Access Compliance Report Public Rights-of-Way (Curb Ramps)

Main Street: ENTONAR_RD Cross Street: ESENCIA_DR Location: N

ADA ID: RPRK211119114714 Ramp Type: Type 4 - Parallel Initial Pass/Fail: Fail Overall Compliance: No Severity Score: 16

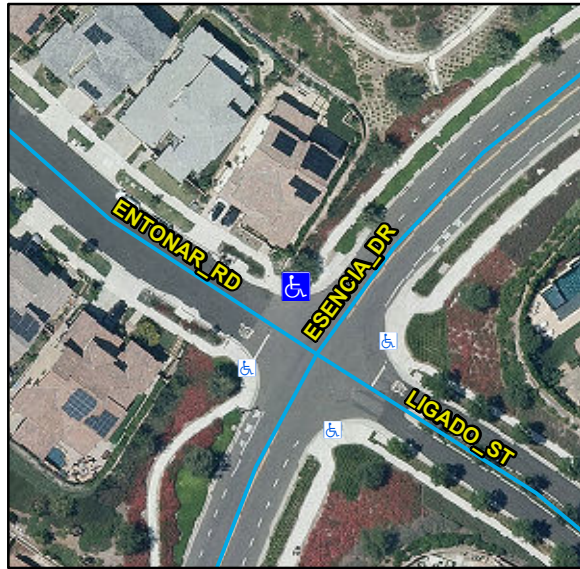
Compliance	Description	Data	Compliance	Description	Data
N/A	Ramp Length LT (in)	115	N/A	Ramp Length RT (in)	106
Yes	Ramp Width LT (in)	89	Yes	Ramp Width RT (in)	89
Yes	Ramp Run Slope LT (%)	0	No	Ramp Run Slope RT (%)	9.6
No	Ramp Cross Slope LT (%)	4.7	Yes	Ramp Cross Slope RT (%)	0
N/A	Landing Present	N/A	N/A	DWS Provided	N/A
N/A	Landing Length (in)	N/A	N/A	DWS Contrast	N/A
N/A	Landing Width (in)	N/A	N/A	DWS Length (in)	N/A
N/A	Landing Run Slope (%)	N/A	N/A	DWS Full Width	N/A
N/A	Landing Cross Slope (%)	N/A		DWS Offset Type	N/A
N/A	Landing Movement Obstructed?	N/A	N/A	DWS Offset Left (in)	N/A
	Landing Movement Type	N/A	N/A	DWS Offset Right (in)	N/A
N/A	Landing Shared	N/A			
N/A	Clear Space	Yes			
N/A	Clear Space To Crosswalk (in)	N/A			
N/A	Marked Crosswalk 1	No	N/A	Marked Crosswalk 2	No
	Crossing 1 Direction	SW		Crossing 2 Direction	SE
	Marked Crosswalk 1 Width (in)	N/A		Marked Crosswalk 2 Width (in)	N/A
N/A	Ramp Inside Crosswalk 1	N/A	N/A	Ramp Inside Crosswalk 2	N/A

Crossing 1 Slope (%)	1		Crossing 2 Slope (%)	0.5
	Crossing 1 Cross Slope (%)	0.9		Crossing 2 Cross Slope (%)	5.1
N/A	Gutter Ponding	N/A	N/A	Curb Slope	11.4
Yes	Gutter Lip Height (in)	0		Road Run Slope (%)	3.3
N/A	Gutter Run Slope (%)	N/A		Road Cross Slope (%)	4.9
N/A	Gutter Cross Slope (%)	N/A	Yes	Perpendicular Joint Present	Yes
Yes	Overall Surface Condition	Acceptable			
	Cross Gutter Present?	No		Spandrel Present?	No
	Replace Cross Gutter?	N/A		Replace Spandrel?	N/A

Remove & Replace Curb Ramp With Two New Directional Ramps or Equivalent.
